1444 S. POTOMAC

2ND FLOOR WHITE BOX
AURORA, COLORADO 80012

(For Tenant Improvement Permit Only)

City of Aurora Building Division
Reviewed for Code Compliance
Approved as Noted: *pmckown*
Date: *Dec 06, 2016*
2015 INTERNATIONAL CODES & 2014 NEC

1 ELECTRICAL FLOOR PLAN
SCALE: 1/8" = 1'-0"

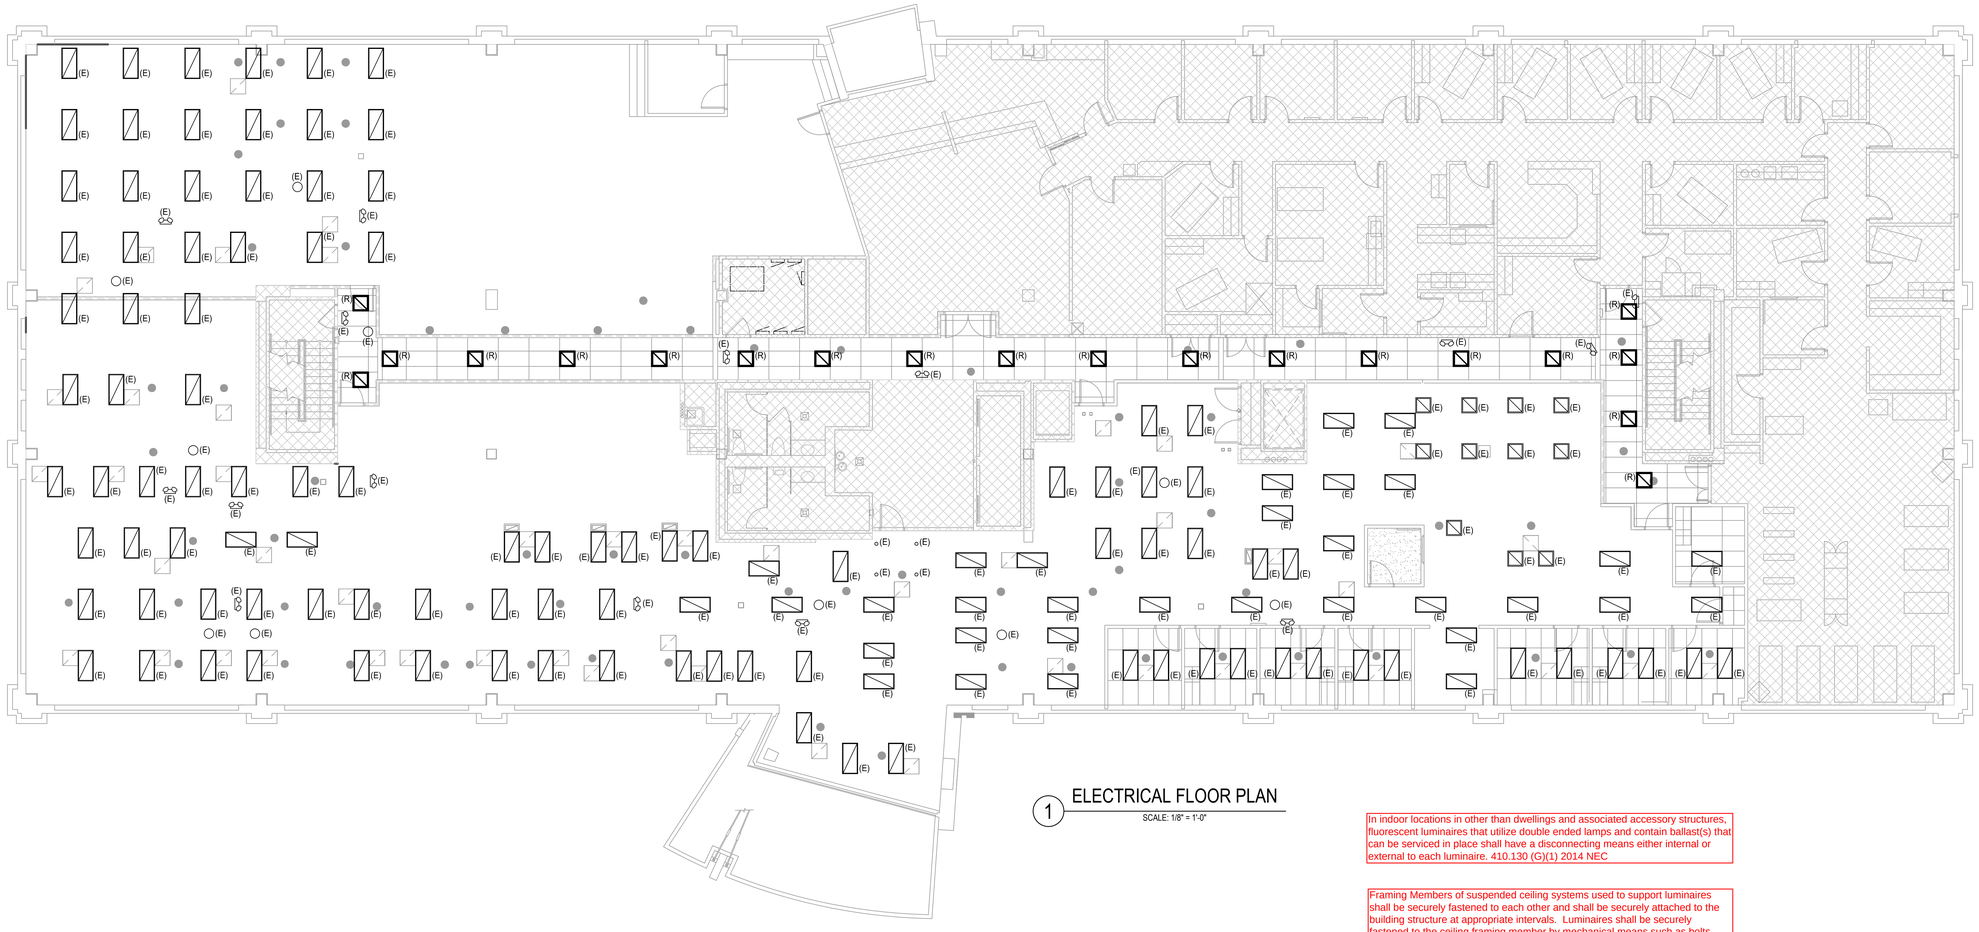
This plan was reviewed for adopted codes and **NOT** for compliance with **ADA** or **FHA** accessibility requirements. Contact 800-949-4232 (**ADA**) and 303-894-7822 x 325 (**FHA**) for federal accessibility requirements that apply to your project.

Locate receptacles a minimum of 15" AFF and locate light switches, pull boxes, thermostats, etc. a maximum of 44" AFF.
2009 ICC/ANSI 117.1 308

In indoor locations in other than dwellings and associated accessory structures, fluorescent luminaires that utilize double ended lamps and contain ballast(s) that can be serviced in place shall have a disconnecting means either internal or external to each luminaire. 410.130 (G)(1) 2014 NEC
